Appendix H. Public Notice, Comment Letters, and MPCA Response-to-Comments

This appendix contains the public comments received during the public notice of the comprehensive update to Minnesota's Regional Haze State Implementation Plan (SIP). The public notice for the comprehensive update to Minnesota's Regional Haze SIP was published in the State Register on August 22, 2022, the public comment period commenced on August 22, 2022, and ended on October 7, 2022. During the public notice period, a copy of the SIP revision was made available at the MPCA office located in St. Paul and on the MPCA's website.

Figure 1 Visibility Trend versus URP – Boundary Waters Canoe Area (BOWA1) and Voyageurs National Park (VOYA1)

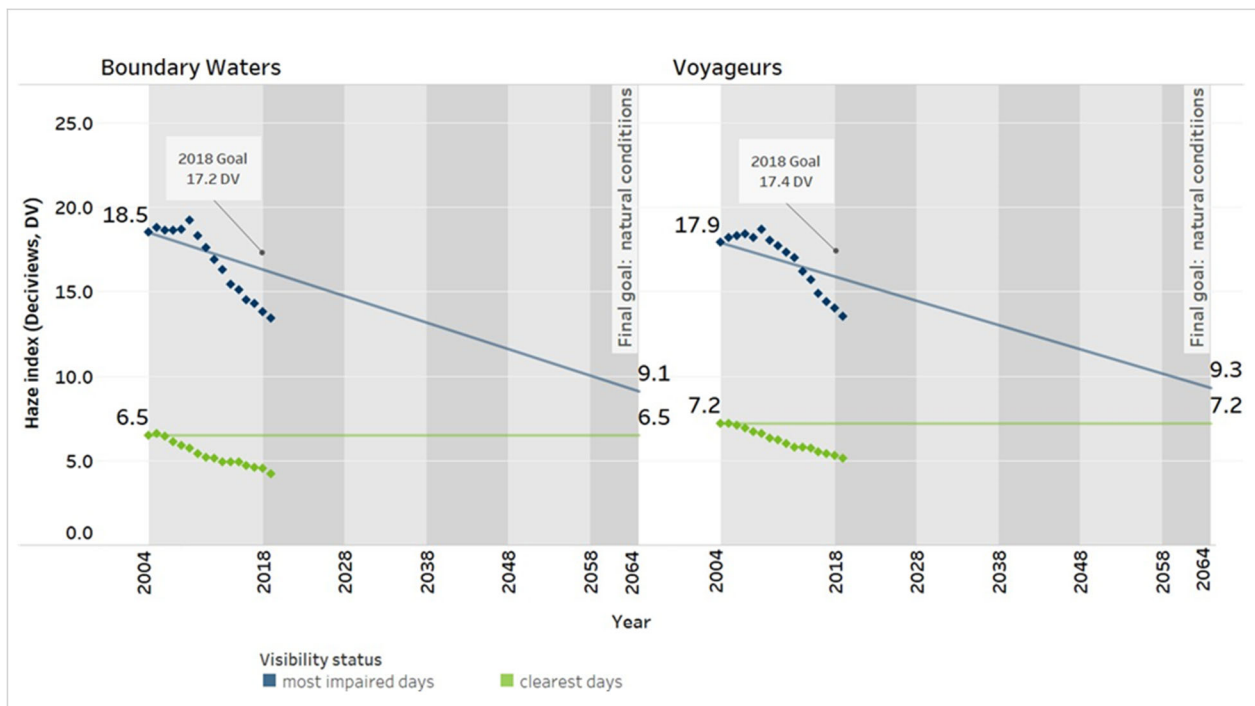
MPCA's low Q/d threshold (4.6) selection was particularly surprising given that visibility in Minnesota Class I areas is already below the uniform rate of progress (URP) "glide-path" and approaching natural visibility. Figure 1 demonstrates the visibility trends for the Boundary Waters Canoe Area Wilderness (BOWA), Voyageurs National Park (Voyageurs), and Isle Royal National Park.

Figure 2 Olivia Wind Rose

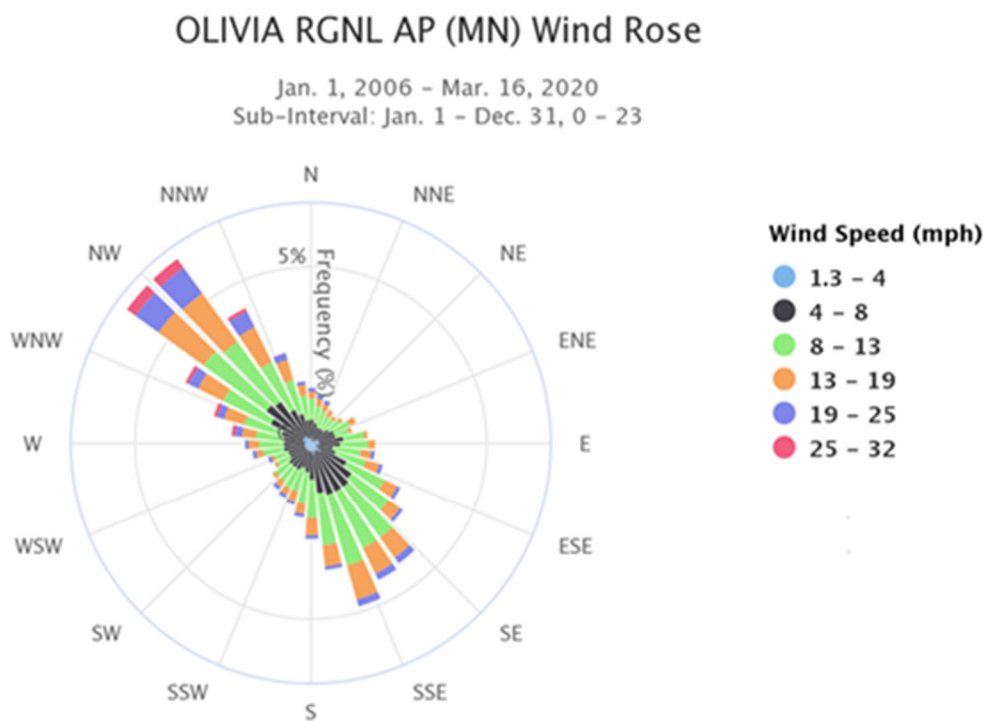
SMBSC provided a wind rose in correspondence with MPCA that the predominant wind directions near SMBSC are from the northwest and southeast/south-southeast, while all the Upper Midwest Class I Areas lie to the northeast. Refer to Figure 2 for details

The wind frequency from the southwest that is a precondition for transport SMBSC emissions to any of the Upper Midwest Class I areas is very rare (less than 1% of the time). This low frequency is compounded by SMBSC's 400-450 km distance to the nearest Upper Midwest Class I area. The distances alone are enough to eliminate SMBSC for consideration as part of any contribution analysis for the Upper Midwest Class I areas.

Figure 3 2018 Most Impaired Days Forward Trajectories

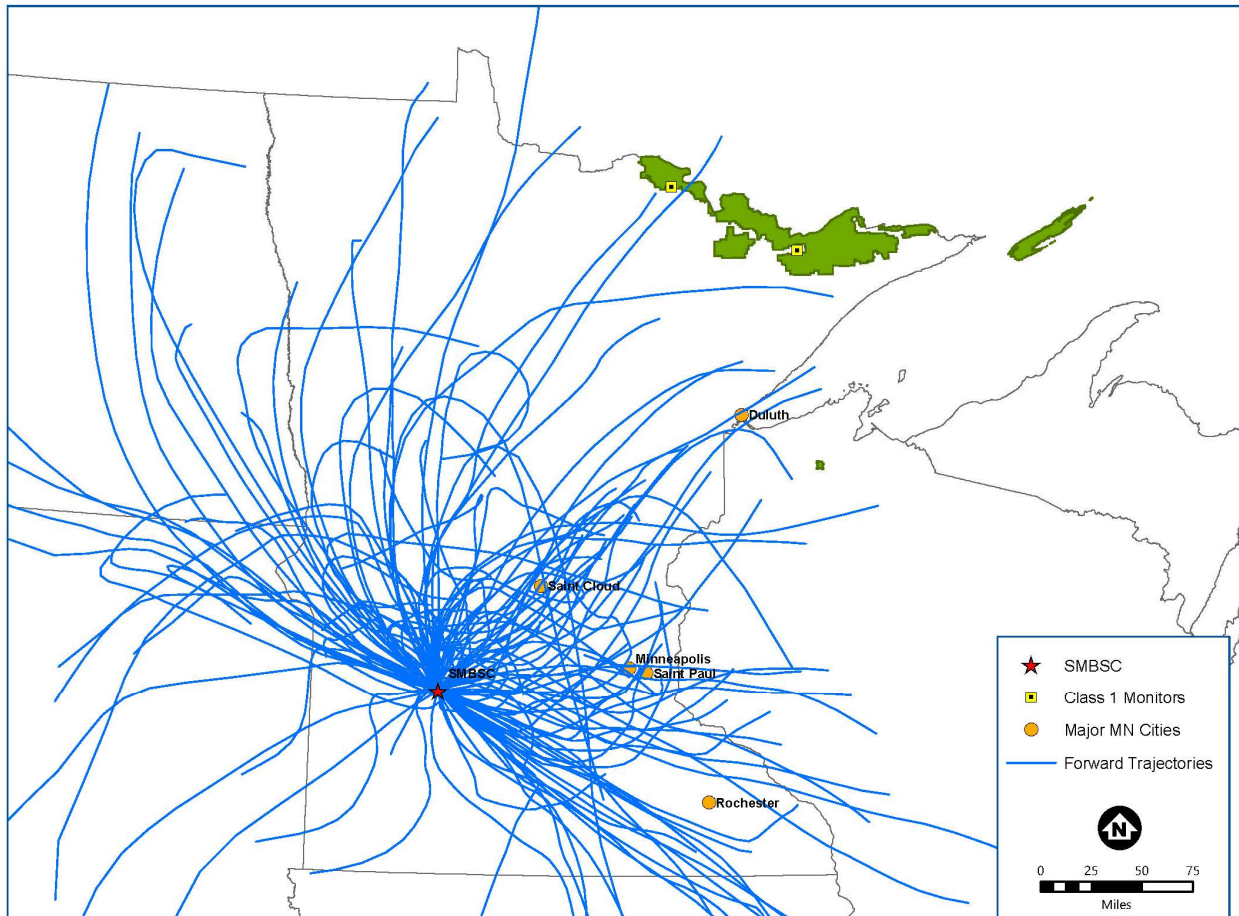
In addition, SMBSC included a forward-trajectory analysis with the original FFA submission, which is more accurate and sophisticated relative to MPCA's Q/d analysis for source inclusion. Refer to Figure 3.

The analysis indicates that SMBSC's emissions seldom if ever reach the BWCAW and there is only a day or two each year the emissions even reach Voyageurs. Collectively, emissions from SMBSC only have the potential to reach Upper Midwest Class I areas in very rare circumstances, much less have **any** impact on visibility. By the time the emissions reach the Upper Midwest Class I areas, the emissions have undergone maximum dispersion and attenuation.
